Access Compliance Report Public Rights-of-Way (Curb Ramps)

Main Street: O_NEILL_DR Cross Street: NARROW_CANYON_RD Location: SW

ADA ID: RPRK211103152212 Ramp Type: Type 4 - Parallel Initial Pass/Fail: Fail Overall Compliance: No Severity Score: 32

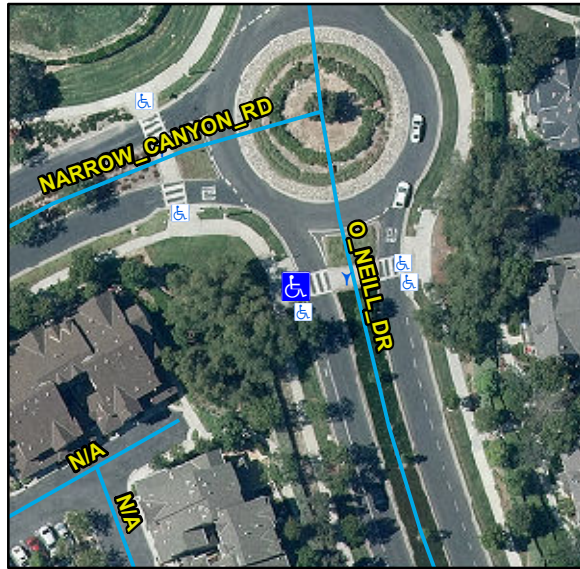
Compliance	Description	Data	Compliance	Description	Data
N/A	Ramp Length LT (in)	-9999	N/A	Ramp Length RT (in)	80
N/A	Ramp Width LT (in)	-9999	Yes	Ramp Width RT (in)	48
N/A	Ramp Run Slope LT (%)	-9999	No	Ramp Run Slope RT (%)	12.6
N/A	Ramp Cross Slope LT (%)	-9999	No	Ramp Cross Slope RT (%)	2.5
N/A	Landing Present	N/A	N/A	DWS Provided	N/A
N/A	Landing Length (in)	N/A	N/A	DWS Contrast	N/A
N/A	Landing Width (in)	N/A	N/A	DWS Length (in)	N/A
N/A	Landing Run Slope (%)	N/A	N/A	DWS Full Width	N/A
N/A	Landing Cross Slope (%)	N/A		DWS Offset Type	N/A
N/A	Landing Movement Obstructed?	N/A	N/A	DWS Offset Left (in)	N/A
	Landing Movement Type	N/A	N/A	DWS Offset Right (in)	N/A
N/A	Landing Shared	N/A			
N/A	Clear Space	N/A			
N/A	Clear Space To Crosswalk (in)	N/A			
N/A	Marked Crosswalk 1	Yes	N/A	Marked Crosswalk 2	N/A
	Crossing 1 Direction	E		Crossing 2 Direction	N/A
	Marked Crosswalk 1 Width (in)	144		Marked Crosswalk 2 Width (in)	N/A

Remove & Replace Entire Ramp.
